Contract #: 04-0120F4Cty: SF/ALA Rte: 80 PM: 13.2/13.9File #: 69.25B**QUALITY ASSURANCE -- NON-CONFORMANCE REPORT****Location:** Changxing Island, Shanghai, China**Report No:** NCR-000905**Prime Contractor:** American Bridge/Fluor Enterprises, a JV**Date:** 24-Nov-2010**Submitting Contractor:** Zhenhua Port Machinery Company, Ltd (ZPMC), Changxing Island**NCR #:** ZPMC-0867**Type of problem:**

**Reference Description:** New Welding Procedure Not Followed (Rager/McQuaid)**Description of Non-Conformance:**

<b>To:</b>	AMERICAN BRIDGE/FLUOR, A JV 375 BURMA ROAD OAKLAND CA 95607	<b>Date:</b>	25-Nov-2010
<b>Dear:</b>	Mr. Charles Kanapicki	<b>Contract No:</b>	04-0120F4 04-SF-80-13.2 / 13.9
<b>Attention:</b>	Mr. Thomas Nilsson    Project/Fabrication Manager	<b>Job Name:</b>	SAS Superstructure
<b>Subject:</b>	NCR No. ZPMC-0867	<b>Document No:</b>	05.03.06-000862

Contract #: 04-0120F4Cty: SF/ALA Rte: 80 PM: 13.2/13.9File #: xx.25A**QUALITY ASSURANCE -- NON-CONFORMANCE RESOLUTION****Location:** Changxing Island, Shanghai, China**Report No:** NCS-000900**Prime Contractor:** American Bridge/Fluor Enterprises, a JV**Date:** 02-Mar-2011**Submitting Contractor:** Zhenhua Port Machinery Company,

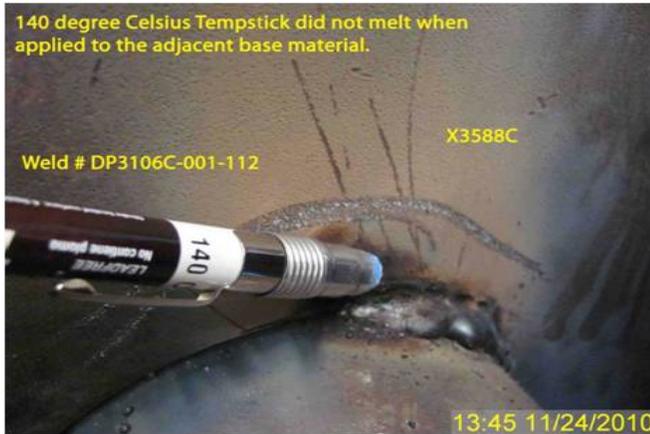
During the Quality Assurance (QA) random in-process observations of the fabrication of OBG Lift 13CE in Bay # 14, this Caltrans QA Inspector observed the following:

ZPMC welding personnel did not appear to be following the New Weld Procedure.

- ZPMC personnel performed welding for the fillet weld between deck panel diaphragm (X3588C) and deck panel "U" rib without adequate preheating of the adjacent base material.

-During the welding This QA Inspector observed a 140 degree Celsius Tempstick did not melt when applied to the adjacent base material.

-Weld number identified as DP3106C-001-112

-The welding performed with Flux Cored Arc Welding (FCAW) process.

-Area was being preheated using electric strip heaters.

-DP3106C was located in Bay # 14

See attached photographs for additional detail.

2) Assembly: F. Preheat shall be applied in such manner to provide a minimum temperature in the area of the weld 165 degree Celsius

ZPMC is providing acceptable NDT of the weld referenced in the NCR and requests closure of this NCR. This weld was misidentified in the NCR as DP3106C-001-112, the actual weld ID is DP3106B-001-112

Contractor provided the NDT report. The report shows the weld is acceptable. The Weld ID DP3106C-001-112 referenced in the NCR has been changed to DP3106B-001-112.
